# UNITED STATES PATENT AND TRADEMARK OFFICE

APPLICATION NO.	FILING DATE	FIRST NAMED INVENTOR	ATTORNEY DOCKET NO.	CONFIRMATION NO.
10/684,792	10/14/2003	James Vlaanderen	00868P0026US	2996

<b>Office Action Summary</b>	<b>Application No.</b>		<b>Applicant(s)</b>	
	10/684,792		VLAANDEREN ET AL.	
	<b>Examiner</b>		<b>Art Unit</b>	
	Gregory W. Adams		3652

***Claim Rejections - 35 USC § 103***

FIG. 1

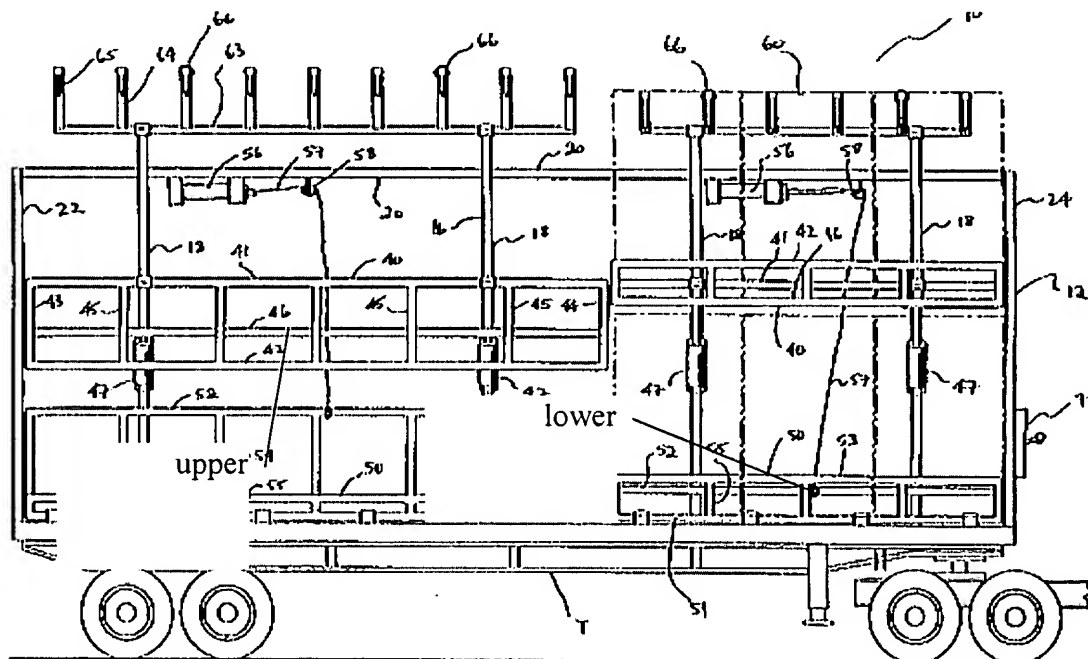
7. With respect to claim 8-9, Babb discloses that lower object supports are shorter than upper object supports (FIG. 1 below), and discloses sharing a first pivot 14. It is

noted that Babb discloses eight (8) object supports such that two (2) lower object supports and linkages thereof share pivot 14, and long links 45 of upper most object support 40 are longer than long links 55 of lowermost object support 50. Babb teaches an apparatus that transports cylindrical objects in rows and tiers, with the ability to pivot rotatably object supports from a loaded position to an unloading position. Para. [0002] – para. [00013]. Therefore, it would have been obvious to one having ordinary skill in the art at the time the invention was made to modify the apparatus of Foote to include shared linkages and object supports which are shorter and longer and longer uppermost long links, as per the teachings of Babb, to transport cylindrical objects in rows and tiers, with the ability to pivot rotatably object supports from a loaded position to an unloading position.

13. With respect to claim 14, Babb discloses that lower object supports are shorter than upper object supports (FIG. 1 above), and discloses sharing a first pivot 14. It is noted that Babb discloses eight (8) object supports such that two (2) lower object supports and linkages thereof share pivot 14, and long links 45 of upper most object support 40 are longer than long links 55 of lowermost object support 50. Babb teaches an apparatus that transports cylindrical objects in rows and tiers, with the ability to pivot rotatably object supports from a loaded position to an unloading position. Para. [0002] – para. [00013]. Therefore, it would have been obvious to one having ordinary skill in the art at the time the invention was made to modify the apparatus of Foote to include shared linkages and object supports which are shorter and longer and longer uppermost

With respect to claim 14, Applicant did not provide arguments, but likely intended to argue that Foote in view of Babb does not disclose object supports of different lengths. Babb discloses that lower object supports are shorter than upper object supports (FIG. 1 reproduced above), and discloses sharing a first pivot 14. It is noted that Babb discloses eight (8) object supports such that two (2) lower object supports

and linkages thereof share pivot 14, and long links 45 of upper most object support 40 are longer than long links 55 of lowermost object support 50. Because one is shorter, Babb discloses different lengths.

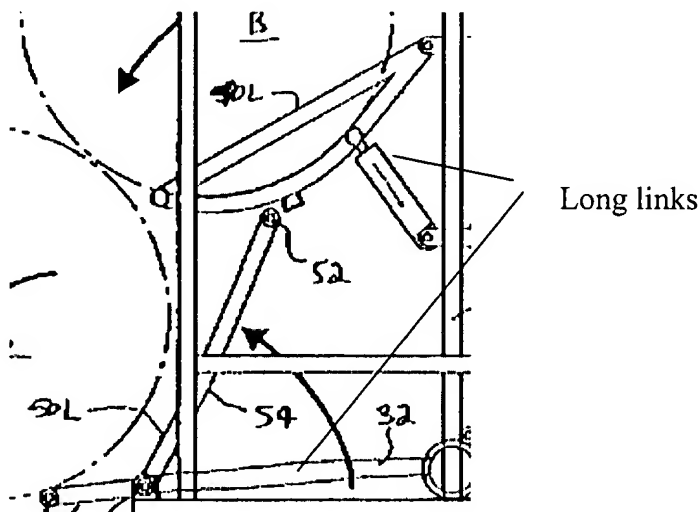
With respect to claim 13, Applicant argues that Foote does not disclose long links for on cradle being longer than long links for another cradle. Fig. 3 reproduced below shows long links and shorts links, with long links for cradle 50L longer than long links for cradle 40L.
